[Docket No. FAA–2023–0671; Project Identifier AD–2022–01428–T; Amendment 39–22469; AD 2023–12–11]

Airworthiness Directives; The Boeing Company Airplanes

ACTION: Final rule.

SUMMARY: The FAA is superseding Airworthiness Directive (AD) 2022–03–20, which applied to all The Boeing Company Model 737–8, 737–9, and 737–8200 airplanes. AD 2022–03–20 required revising the limitations and operating procedures sections of the existing airplane flight manual (AFM) to incorporate limitations prohibiting the use of certain minimum equipment list (MEL) items, and to incorporate operating procedures for calculating takeoff and landing distances, when in the presence of interference from wireless broadband operations in the 3.7–3.98 GHz frequency band (5G C-Band) as identified by Notices to Air Missions (NOTAMs). Since the FAA issued AD 2022–03–20, the FAA determined that additional limitations are needed due to the continued deployment of new 5G C-Band base stations whose signals are expected to cover most of the contiguous United States at transmission frequencies between 3.7–3.98 GHz. This AD requires revising the limitations section of the existing AFM to incorporate limitations prohibiting

Figure 1 to paragraph (g)(2)(i)—*Fundamental Effective Isotropic PSD at Outside Interface of Aircraft Antenna*

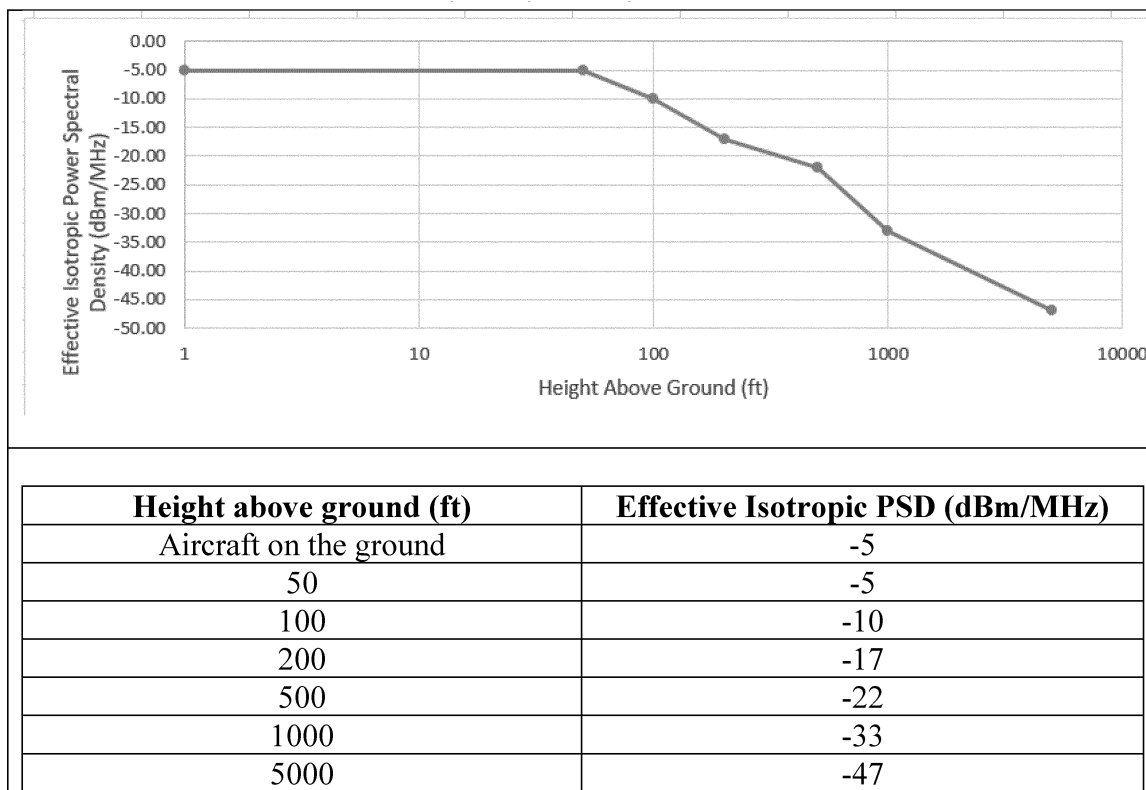
(i) Tolerance to radio altimeter interference, for the fundamental emissions (3.7–3.98 GHz), at or above the power spectral density (PSD) curve threshold specified in figure 1 to paragraph (g)(2)(i) of this AD.

Figure 2 to paragraph (g)(2)(ii)—*Spurious Effective Isotropic PSD at Outside Interface of Aircraft Antenna*

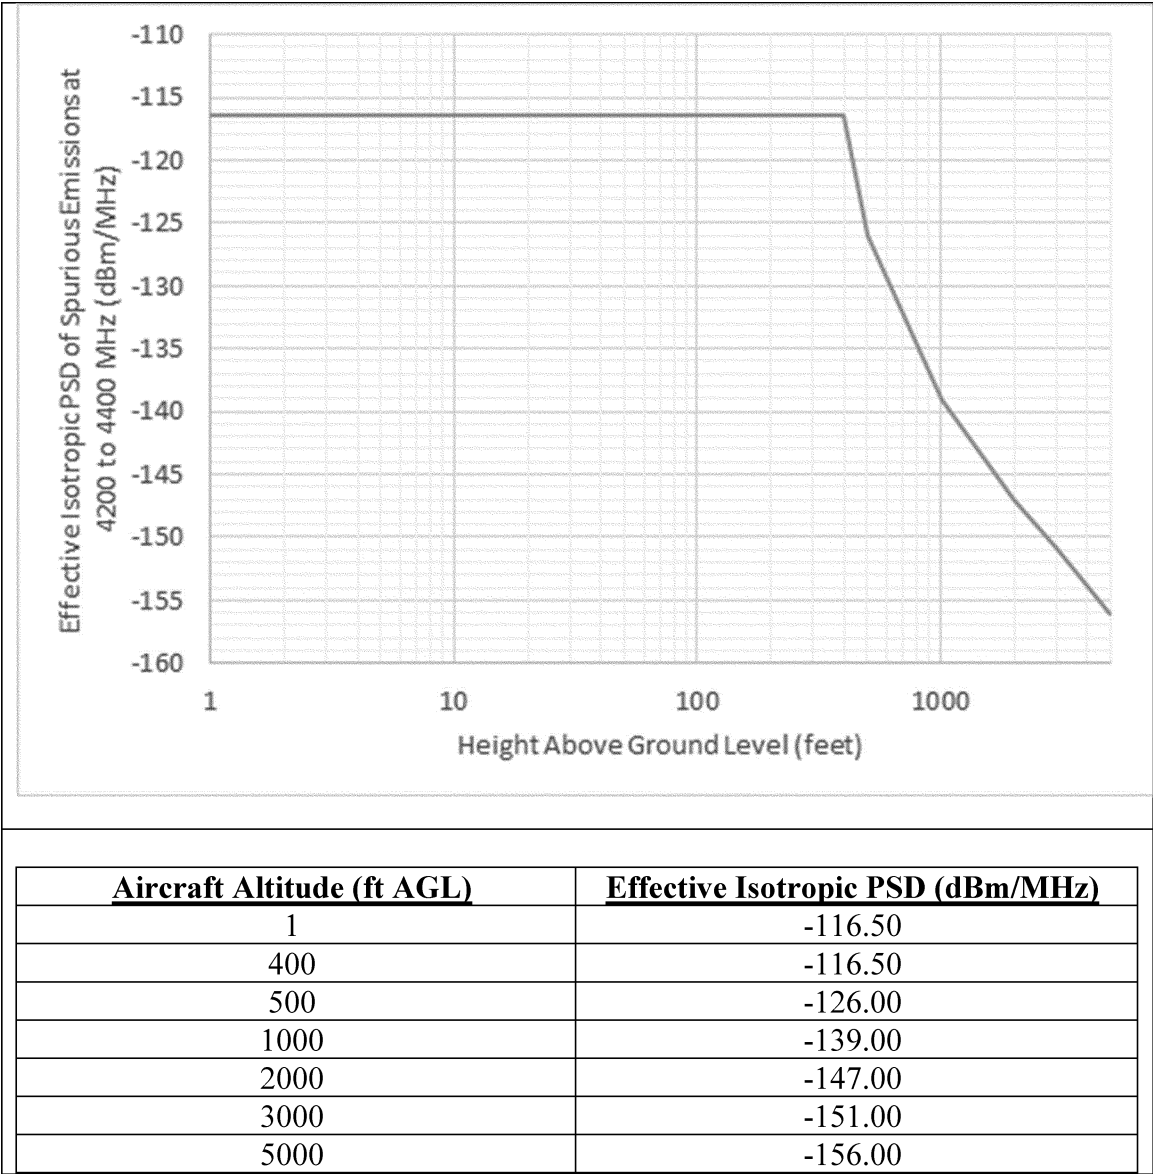
(ii) Tolerance to radio altimeter interference, for the spurious emissions (3.7–

3.98 GHz), at or above the PSD curve

threshold specified in figure 2 to paragraph (g)(2)(ii) of this AD.
